ADDENDUM NO. 10 TO PROJECT NO. 44362

CONSTRUCTION - PROJECT LABOR AGREEMENT PROJECT

**PROVIDE COMBINED SUPPORT MAINTENANCE SHOP
516 – ROUTE 216
STORMVILLE, NEW YORK 12582**

August 30, 2013

OVERALL SITE PLAN
 SHEET TITLE
 DRAWING NUMBER
C-103

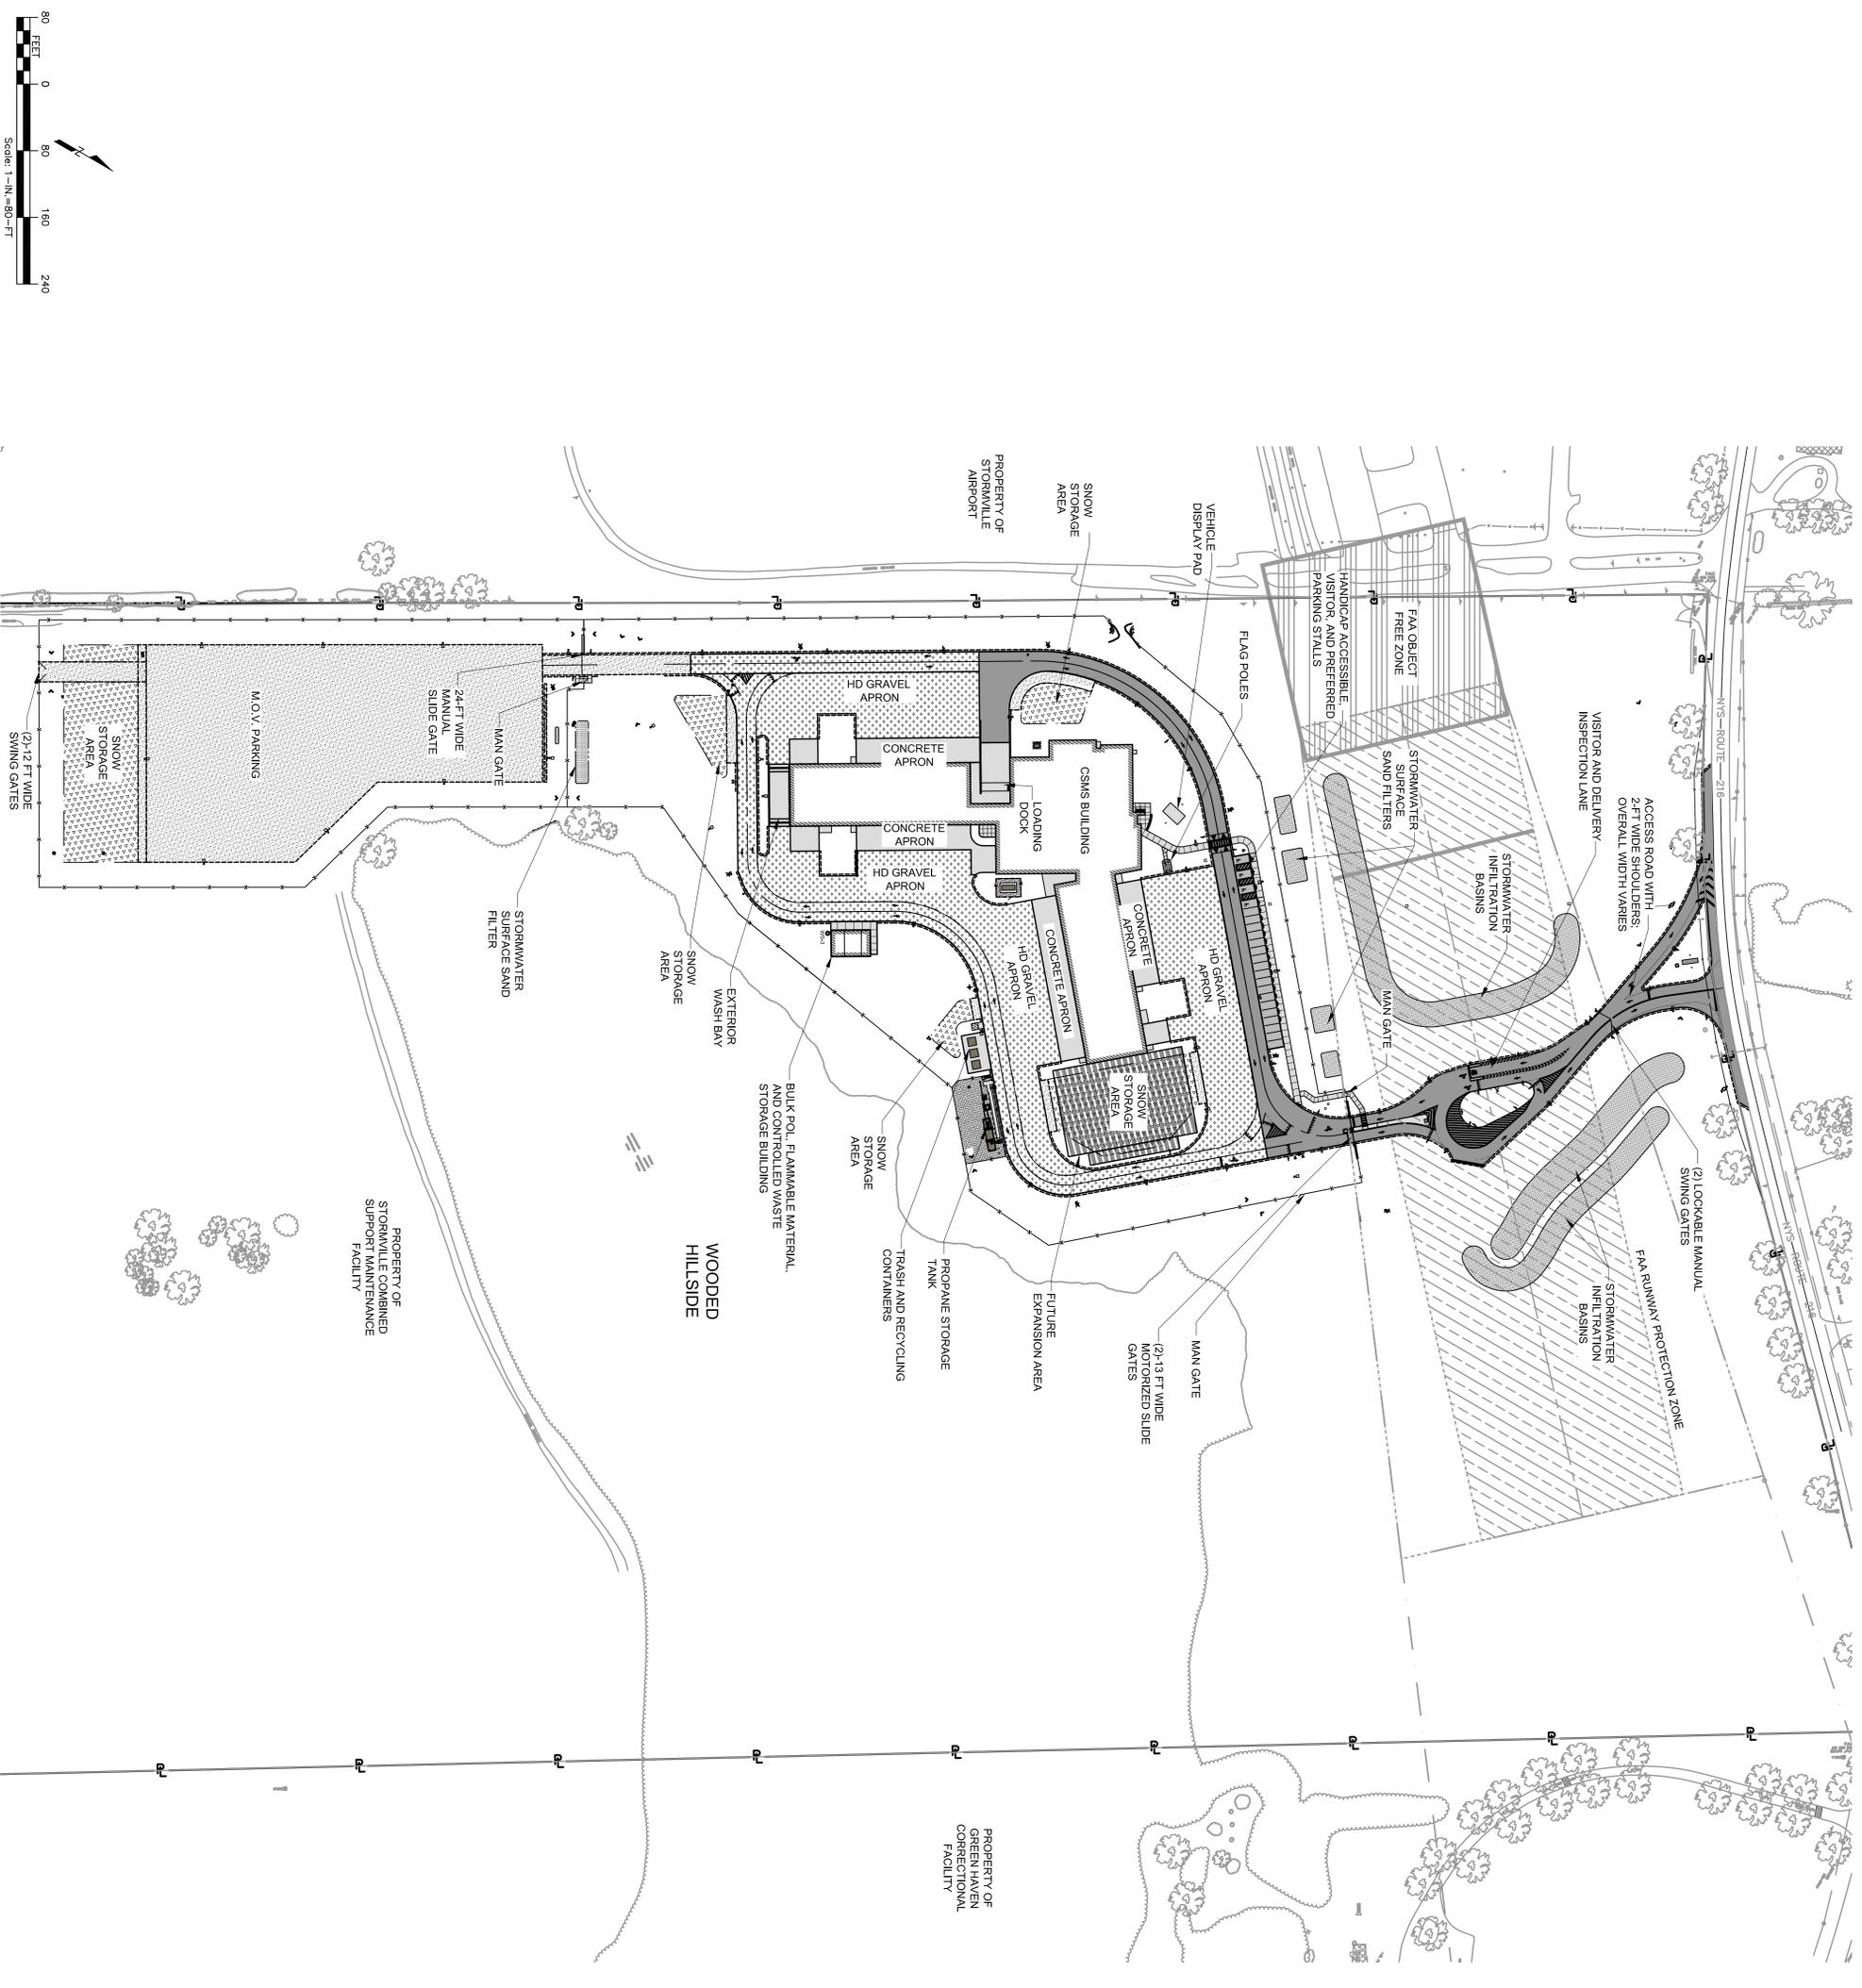
- 9. Drawing C-125: Delete in its entirety.
- 10. Drawing A-107: Delete in its entirety.
- 11. Revised Drawing:
 - a. Drawing No. C-103, noted “REVISED 8/30/2013” accompanies this Addendum and supersedes the same numbered originally issued drawing.

Changes include:

- 1. Privately Owned Vehicle (POV) parking lot is being removed from the project. This includes the paving, striping, curbing, lighting, walkways, and signage. Contractor shall grade area to match finished contours on plans, provide positive drainage, and appropriate cover over proposed utilities as directed by project details. Area shall be seeded with seed mix No. 1. This change also affects C-102, C-103, C-120, C-121, C-130, C-131, C-140, C-141, C-145, C-146, C-150, C-151, C-154, C-160, C-161, and C-170 which depicts information associated with the POV parking lot.

- 2. Reinforced concrete aprons shall be changed to extend 30-ft from face of building instead of 60-ft from face of building. This change also affects Drawing Nos. C-102, C-103, C-122, C-124, C-132, C-142, C-147, C-152, C-154, C-162, C-170 which depict information associated with the concrete aprons located at the face of the building.

- 3. Roadway from south side of loading dock towards MOV parking lot and aprons around the building previously designated as heavy duty asphalt shall now be installed as heavy duty gravel pavement section consisting of 6.5-in of type 2 stone on top of a biaxial geogrid layer, placed over 12-in of type 2 subbase compacted in (2) six inch lifts over woven geotextile fabric.

- 4. Remove concrete loading ramp from base bid condition.
- 12. Drawing No. C-124:
 - a. The contraction joint (type F) located at 30-ft away from the building face and the dummy joint (type H) located at 45-ft away from the building shall be eliminated at each of the concrete aprons. The thickened edge joint (type A) formerly located at 60-ft away from the building shall now be located at the edge which is now 30-ft away from the building.

ALTERNATE BID ITEMS
 DRAWING NUMBER:
C-125

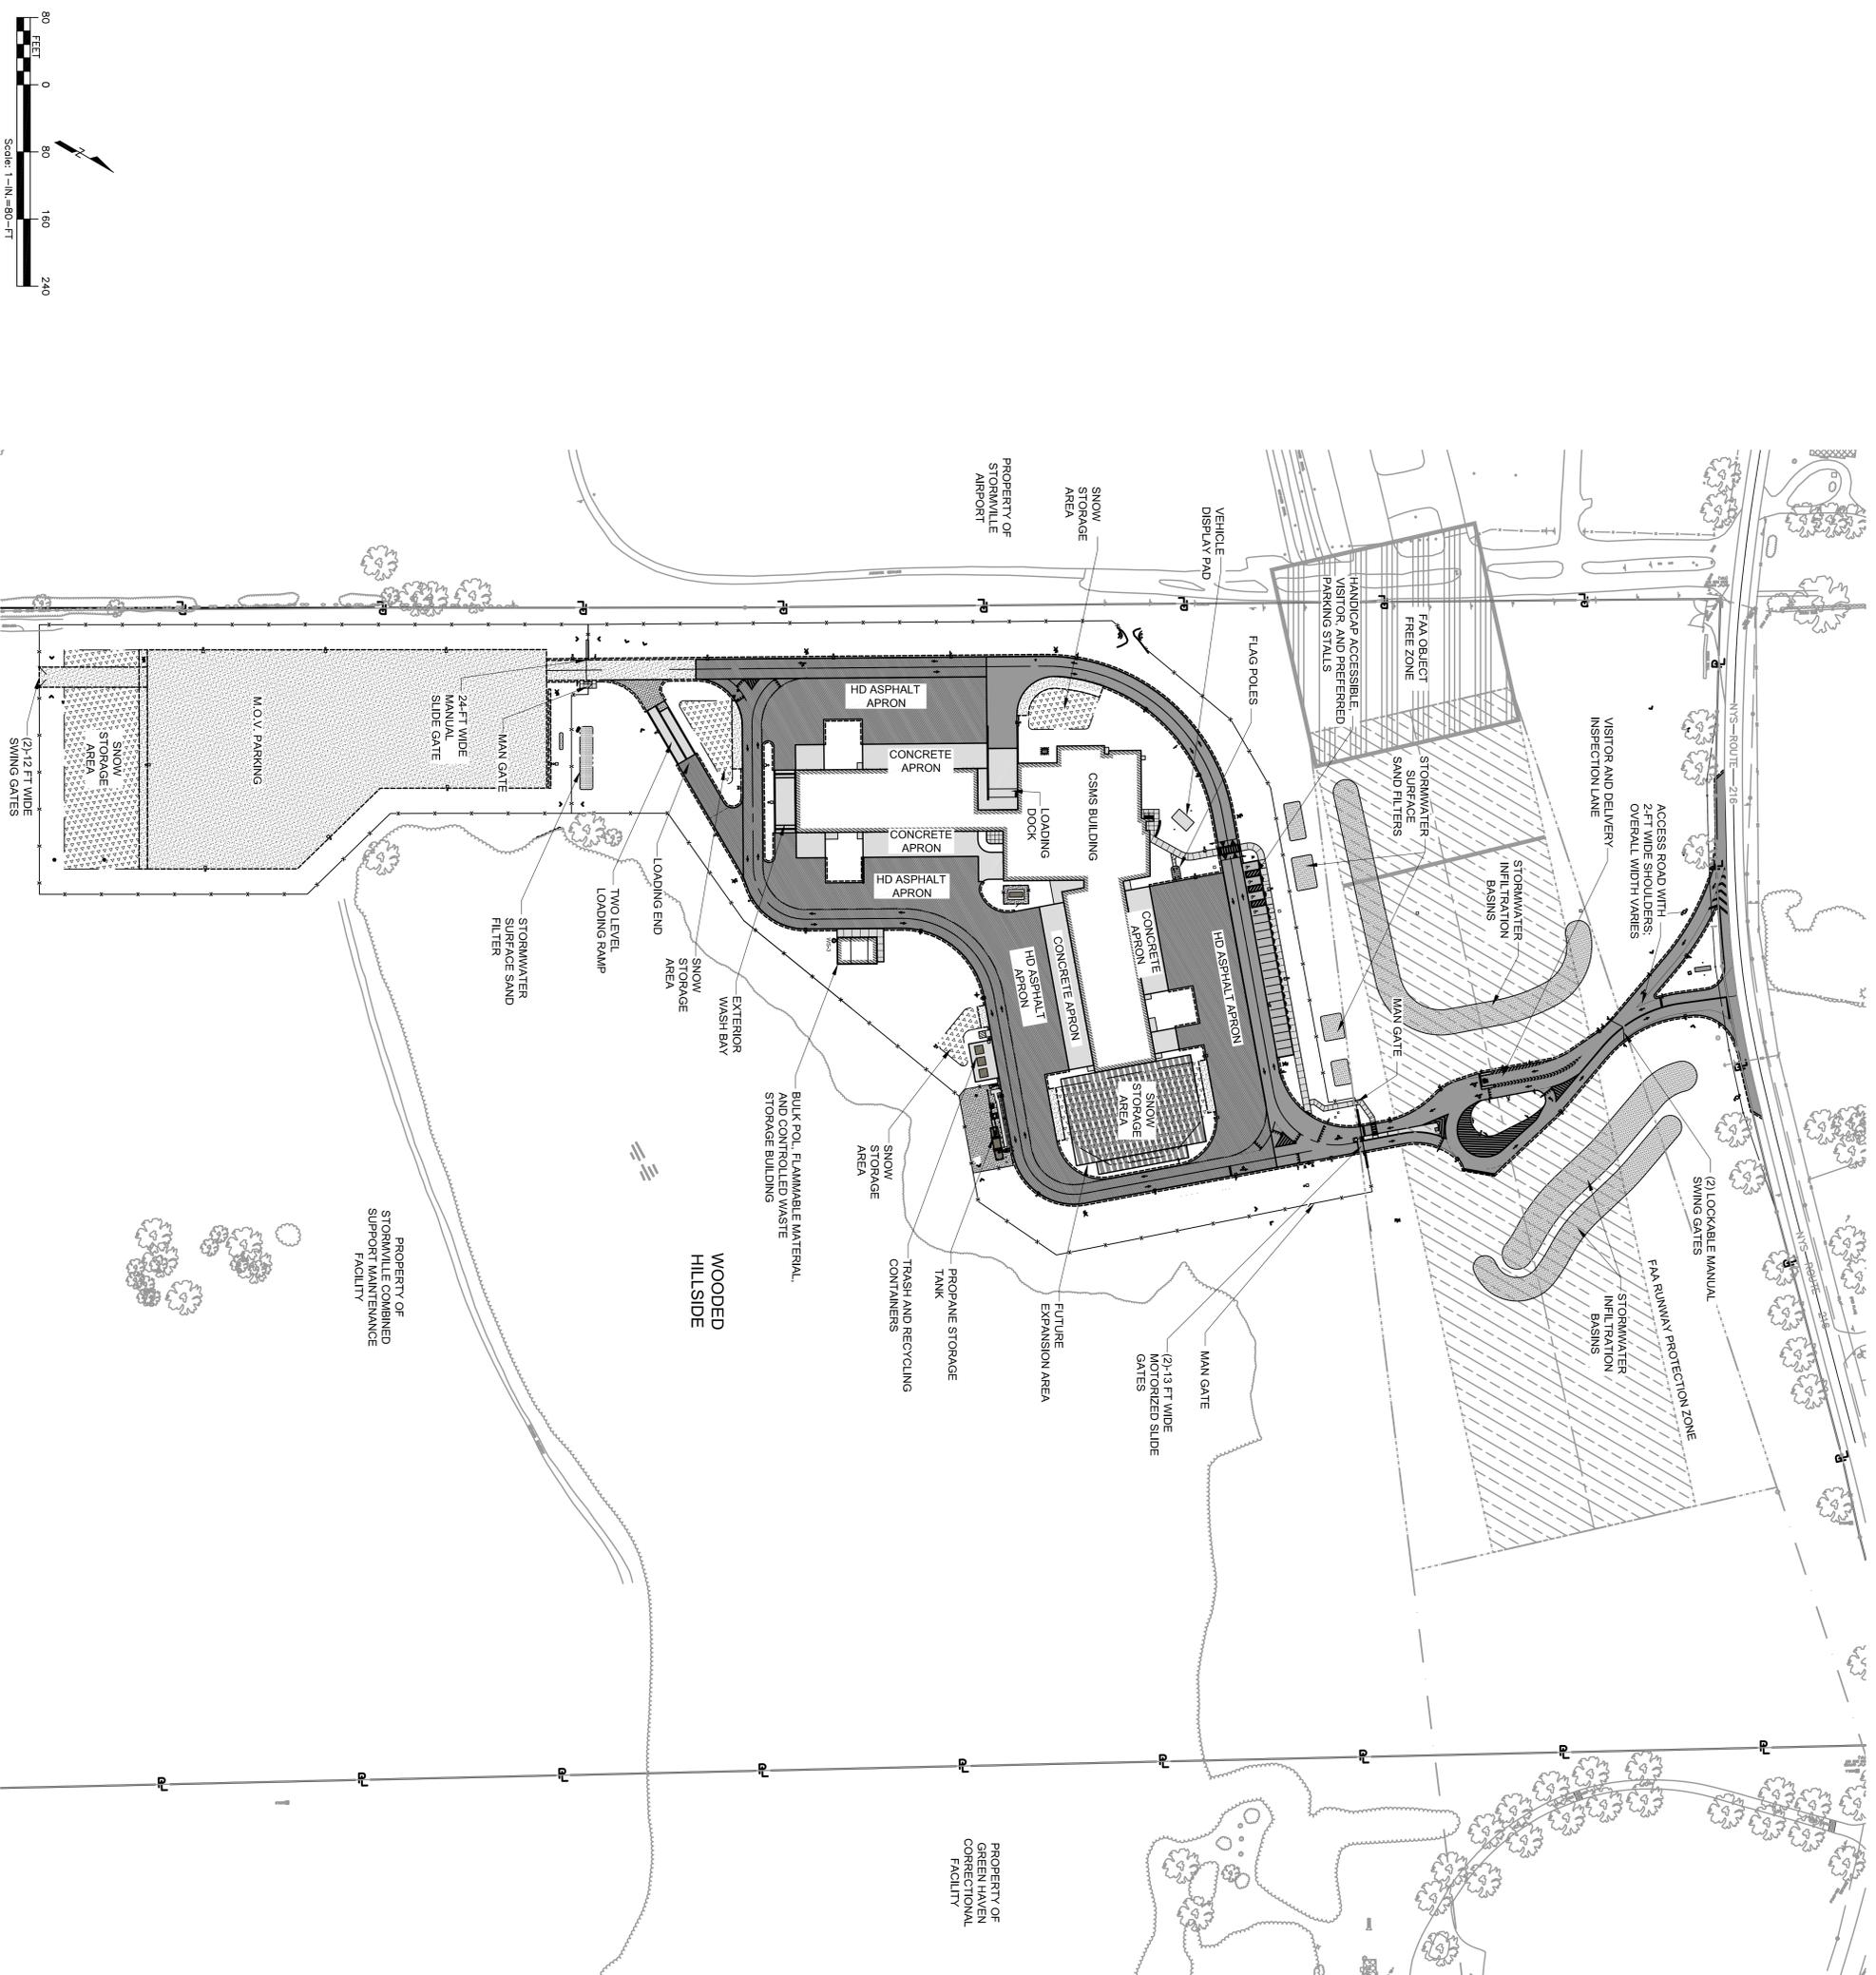
- a. Drawing No. C-125, noted “REVISED 8/30/2013” accompanies this Addendum and supersedes the same numbered originally issued drawing.

Changes include:

1. Original Alternates No. 1, No. 2, and No. 3 have been removed from the project.
 2. Alternate No. 1 now includes roadway from south side of loading dock towards MOV parking lot and aprons around the building shall be installed as heavy duty asphalt consisting of 1.5-in of asphalt wearing course, 2-in of asphalt binder course, and 3-in of asphalt base course over 12-in of type 2 subbase course.

3. Alternate No. 1 also includes install concrete loading ramp.
14. Drawing Nos. C-131, C-132, C-133, C-134, C-135, C-136, C-137, C-234, C-235, C-236, and C-530.

DWG NO:
C-125B

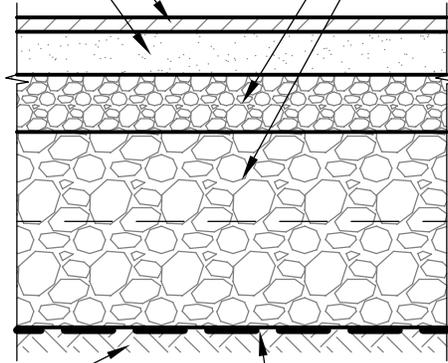
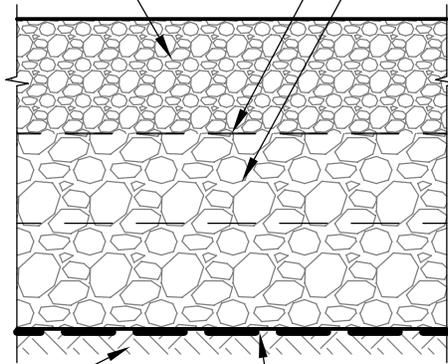
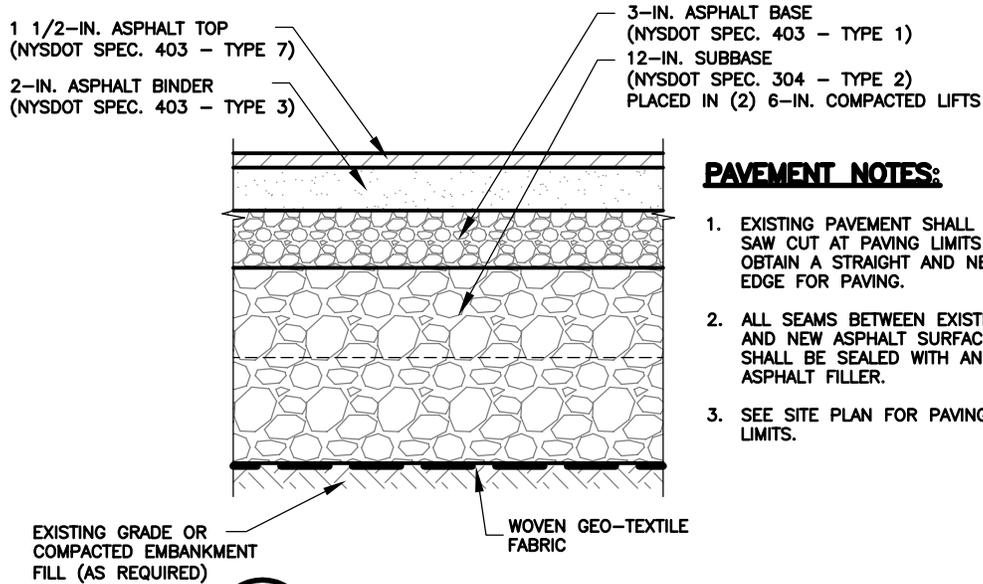
- a. Change 12-in dia ductile iron pipe to 12-in dia HDPE pipe.
 15. Addendum Drawing:
 - a. Drawing No. C-125B, accompanies this Addendum and forms part of the Contract Documents. Drawing includes details for Heavy Duty Gravel Pavement Section for use in base bid and Heavy Duty Pavement Section for Alternate and main driveway.

DWG NO: **C-522B**

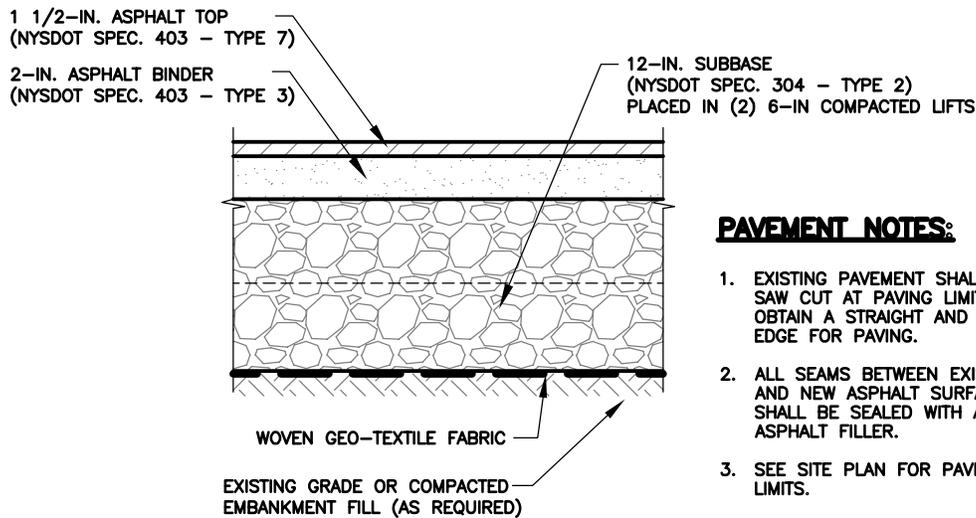
16. Addendum Drawing No. C-522B:
 - a. Drawing No. C-522B, accompanies this Addendum and forms part of the Contract Documents. Replaces Details 1 and 2 on sheet C-522:

1. Change the subbase material from 6-in NYSDOT type 2 and 6-in NYSDOT type 1, to 12-in NYSDOT type 2 placed in (2) 6-in thick compacted lifts.
 17. Drawing H-103: Delete in its entirety.
